AGENDA

PLANNING COMMISSION STAFF REPORT REGULAR AGENDA ITEM No. 1

PROJECT NUMBER / TITLE: FDP-21-04 Burger King

PROJECT NUMBER / TITLE: FDP-21-05 Final Development Plan for Aspen Creek

SHEET NAME LANDSCAPE PLAN

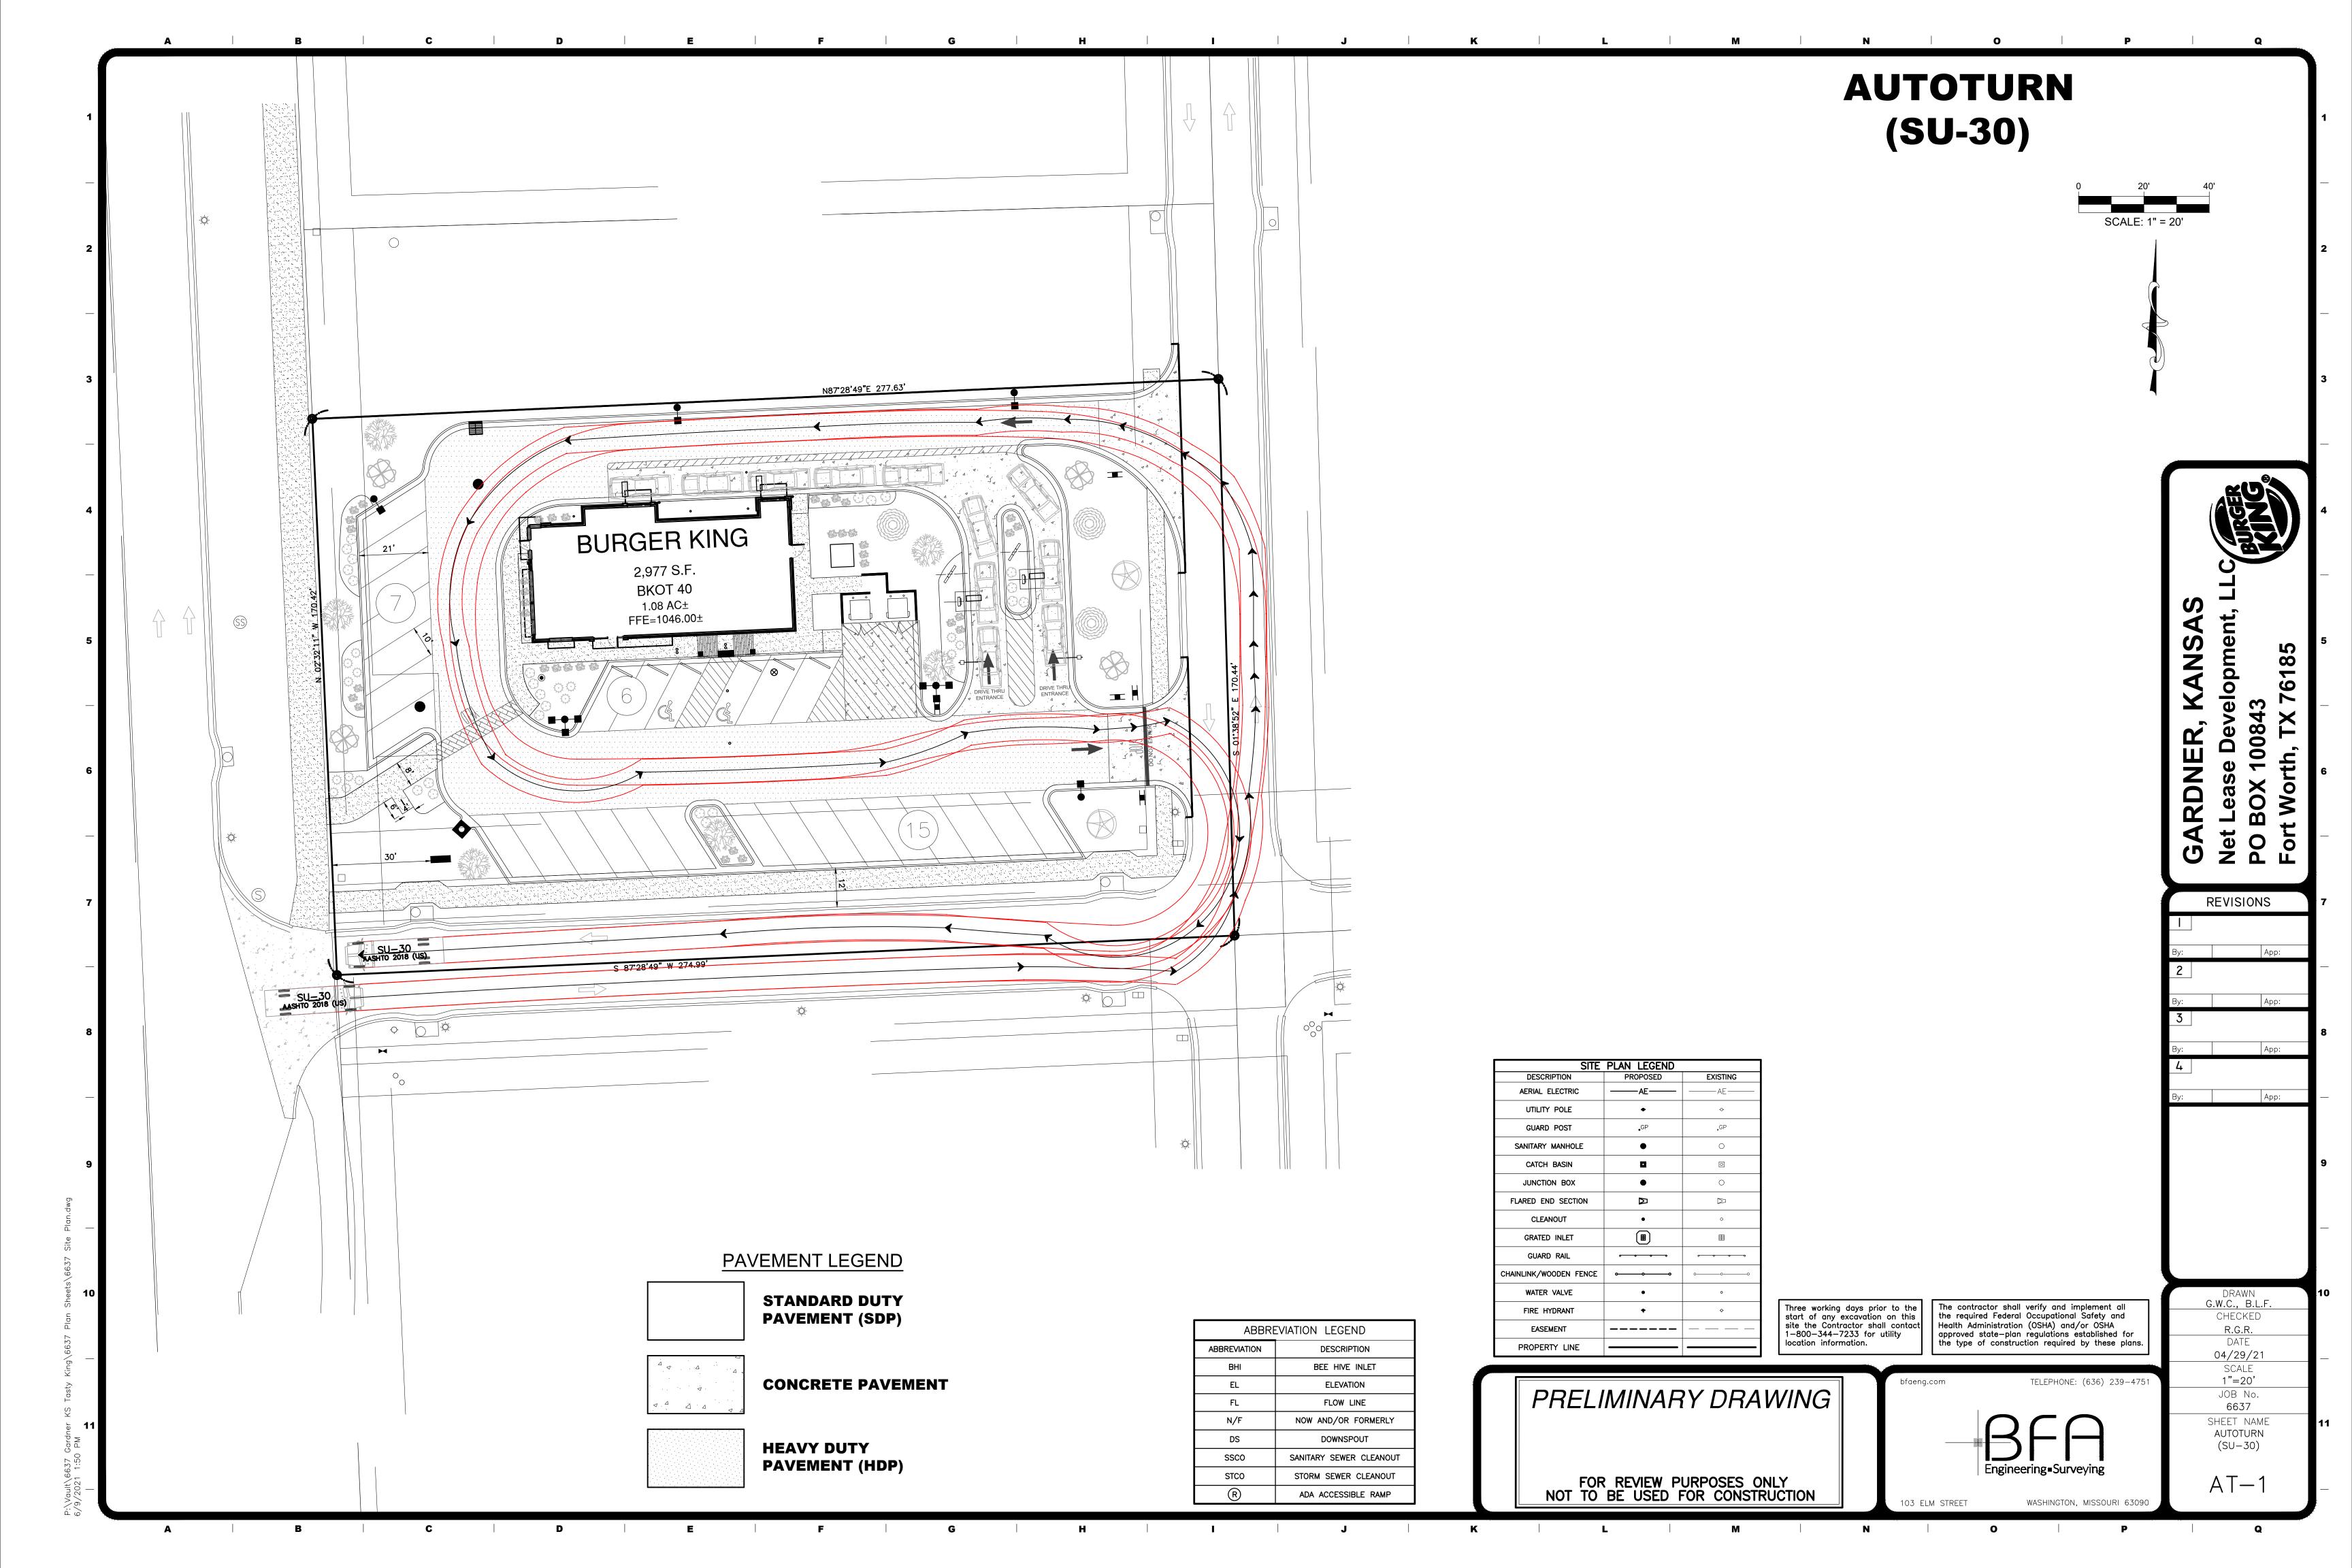
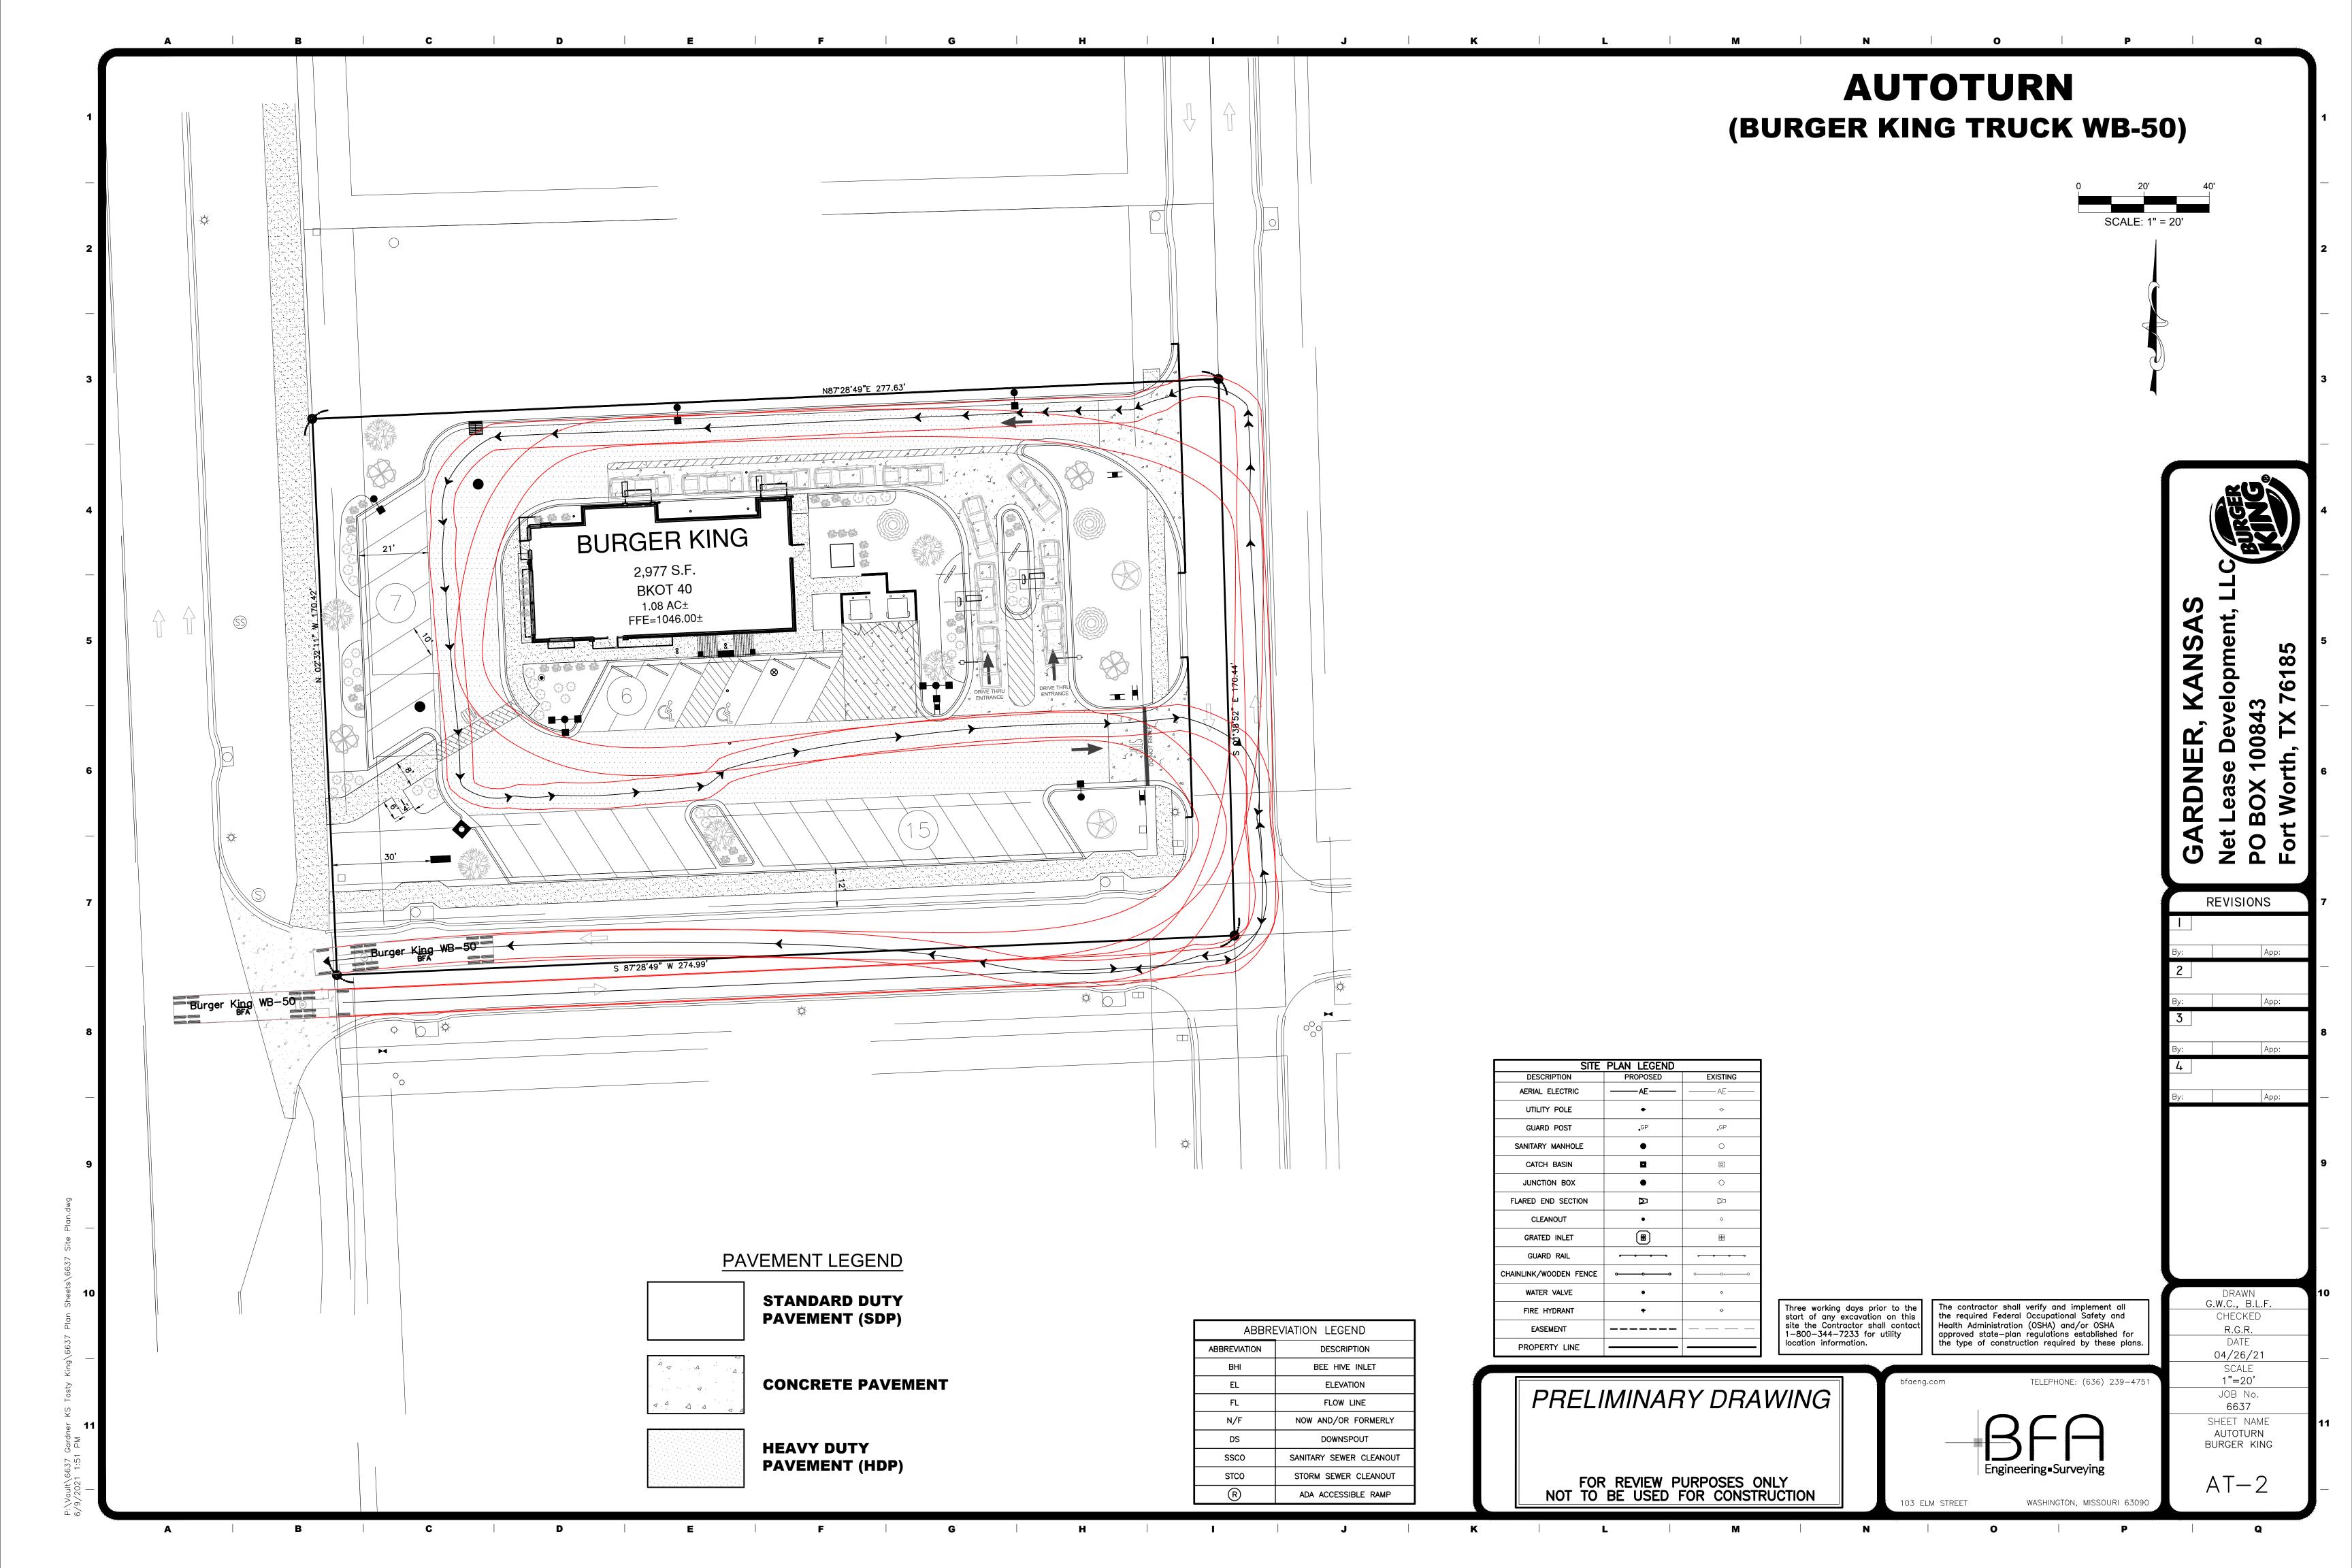
Proposed: Plant additional shrubs along the east façade facing Gardner Road. Only 4 shrubs were required, will plant 24 shrubs in a landscape bed of 4' wide.

Staff Comment: Staff recommends approval of the deviation request as we believe the request is an "equal or better" solution.
